BRAHMAPUTRA PETROCHEMICAL COMPLEX,
LAKWA, ASSAM

DM WATER PLANT AND ASSOCIATED FACILITIES

DOCUMENT NO:	ADIPL/EIL/BCPL/MEC/11001/057	REV. NO.	1
DOCUMENT TITLE:	Mechanical Data Sheet for Degassed Water Pump(SBA Feed)	NO. OF SHEETS:	2

BCPL	EIL JOB NO: 6907	DOC. NO: ADIPL/EIL/BCPL/MEC/11001/064	REV. NO & DATE : 1 & 11.10.2012
EIL	ADIPL JOB NO: P-11001	Doc. Title: Performance Curve Degassed Water Pump(Regeneration)	ISSUE: A
			SHEET NO: 1

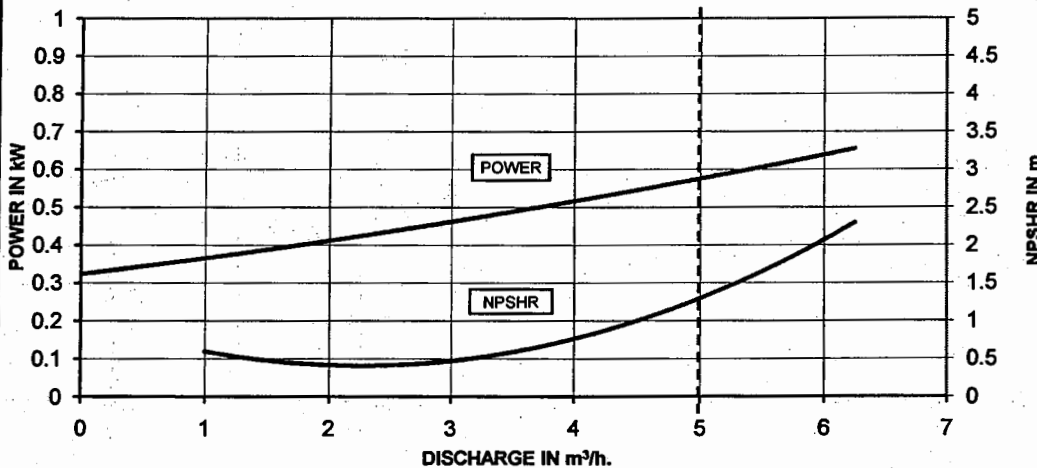
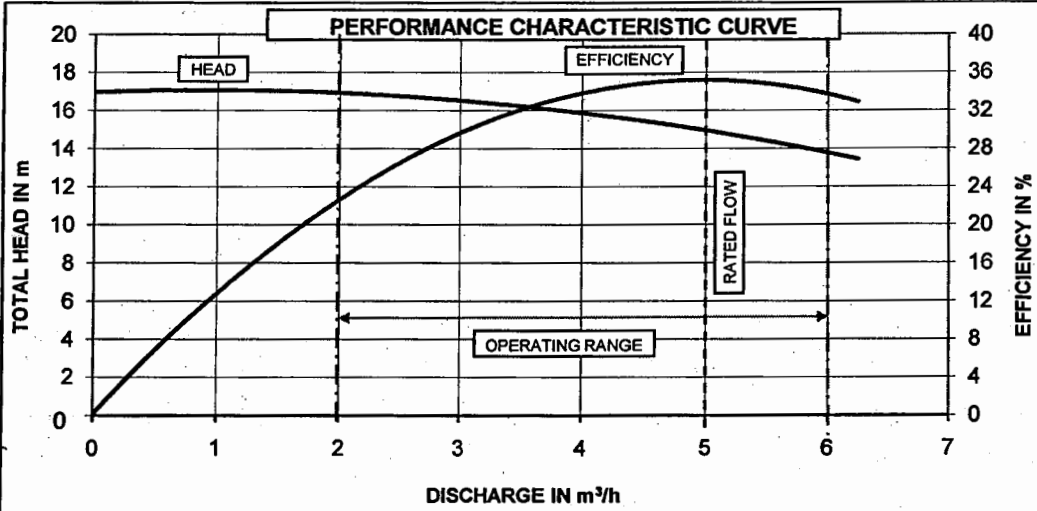
Maximum pumpeller dia

BCPL	EIL JOB NO: 6907	DOC. NO: ADIPL/EIL/BCPL/MEC/11001/069	REV. NO & DATE : 1 & 11.10.2012
EIL	ADIPL JOB NO: P-11001	Doc. Title : Performance Curve for DM Water Pump (Regeneration)	ISSUE: A SHEET NO: 1

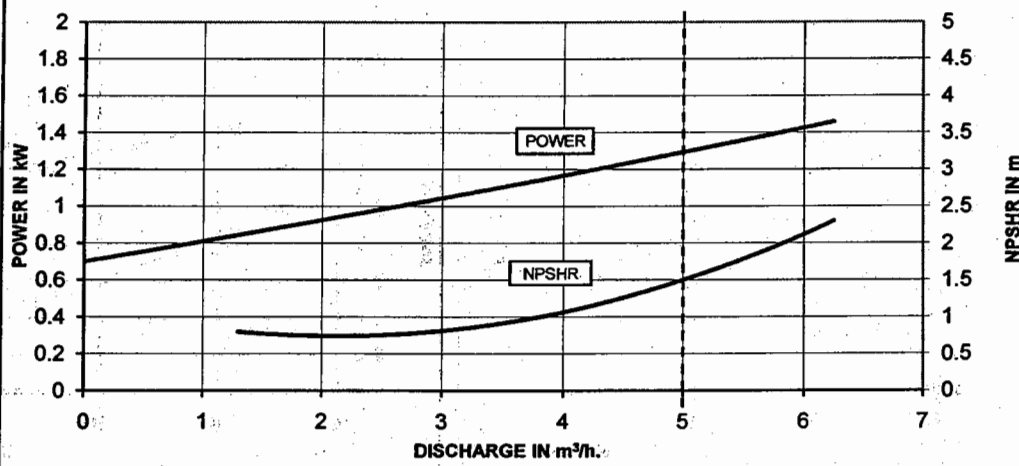
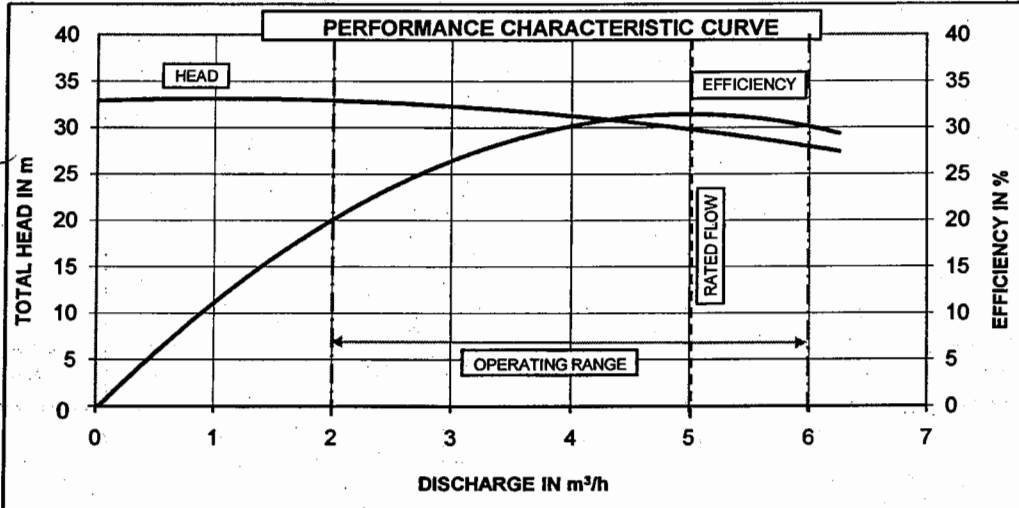
Mention / note
maxi mum dia
impeller dia
across.
